FirstEnergy Nuclear Operating Company

January 30, 2003
PY-CEI/NRR-2665L

Perry Nuclear Power Plant
Docket No. 50-440
License Amendment Request Pursuant to 10CFR50.90: Revision of the Minimum Critical Power Ratio (MCPR) Safety Limit

Figure 2 Reference Core Loading Pattern - Cycle 10

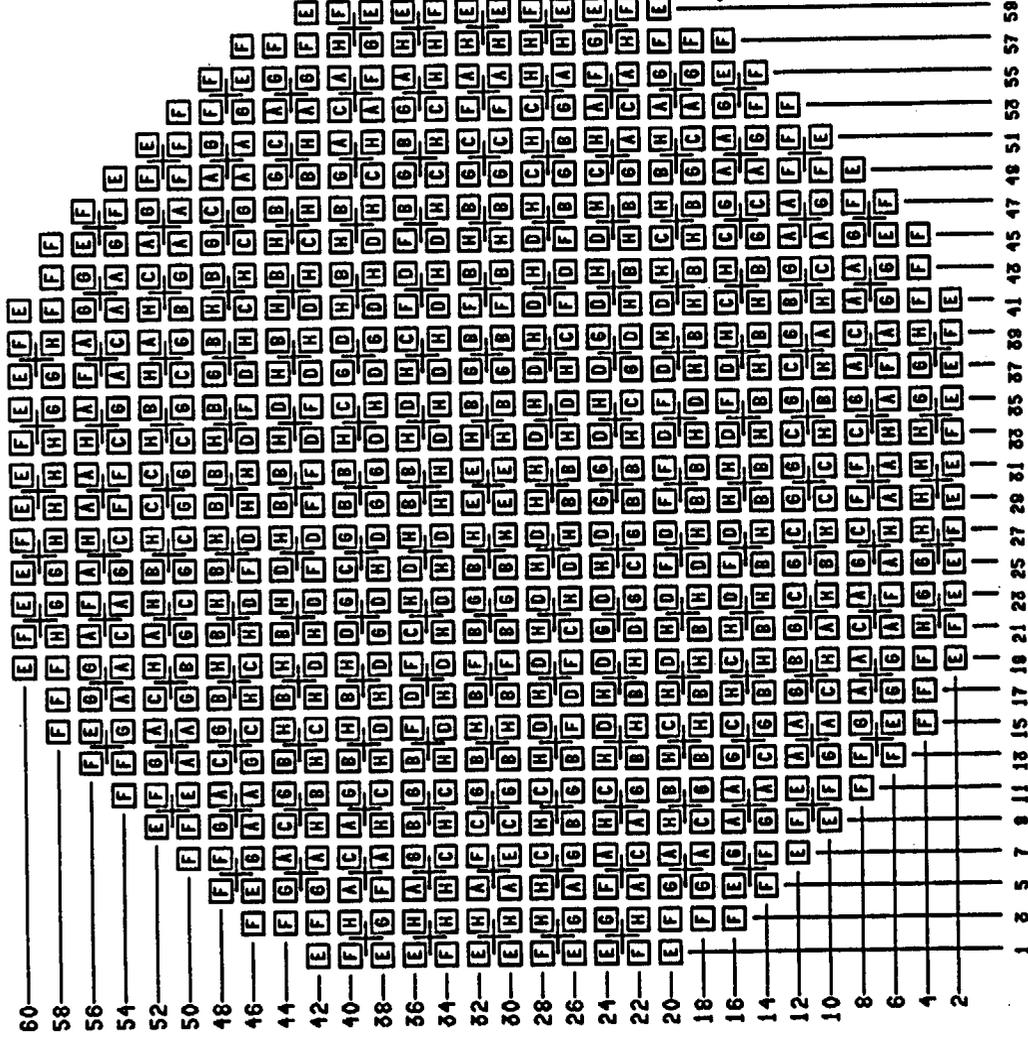
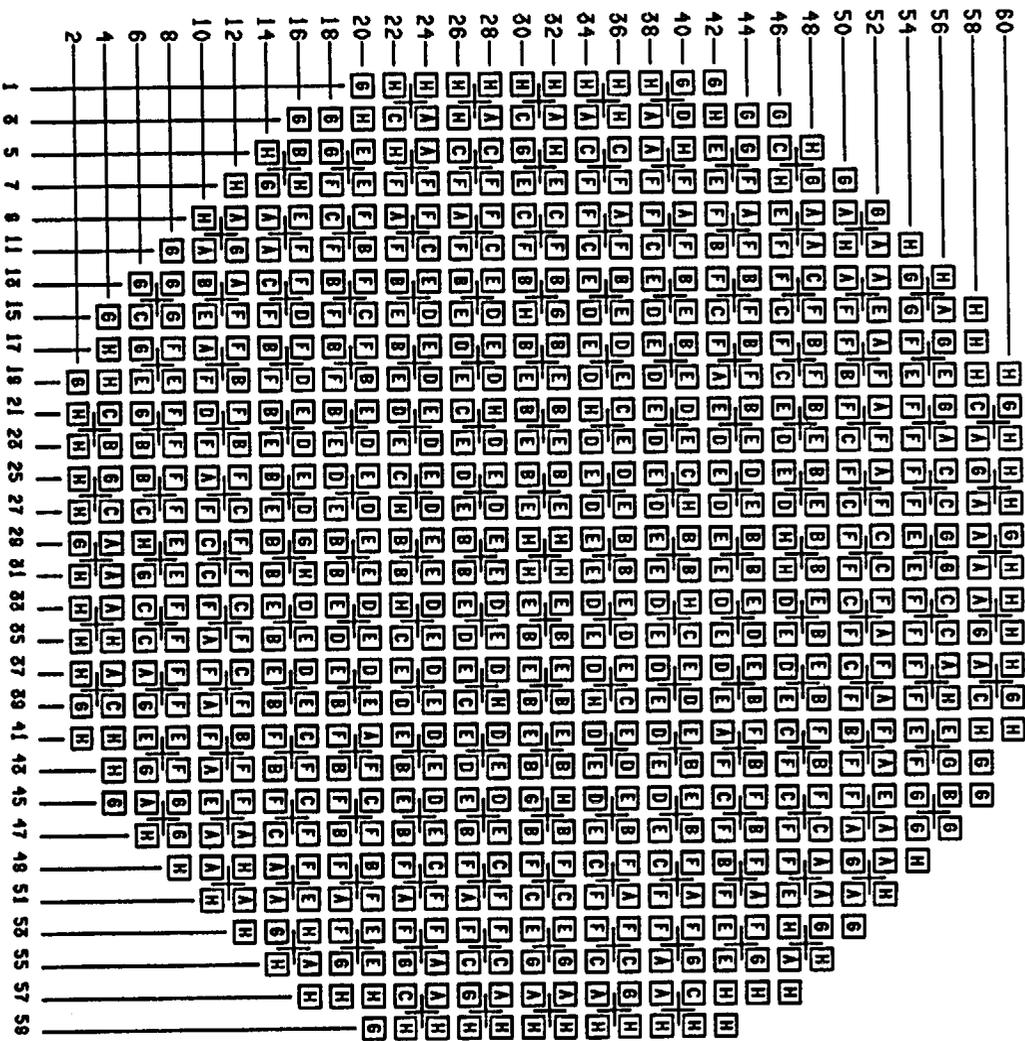
The input parameters and the results of the Global Nuclear Fuel – Americas, LLC (GNF) calculations for the PNPP MCPR Safety Limit values are attached. Attachment 5 provides the non-proprietary version of the GNF document. Attachment 6 provides the proprietary version of the GNF document. A GNF affidavit requesting the withholding of disclosure of the proprietary information contained in Attachment 6 is provided in Attachment 7. Attachments 5 and 6 provide maps showing the Reference Loading Pattern for Fuel Cycles 9 and 10 for comparison.

The core loading information for Perry Unit 1 Cycles 9 and 10 is provided in Figures 1 and 2, respectively. The impact of the fuel loading pattern differences on the calculated SLMCPR is correlated to the values of [[]]
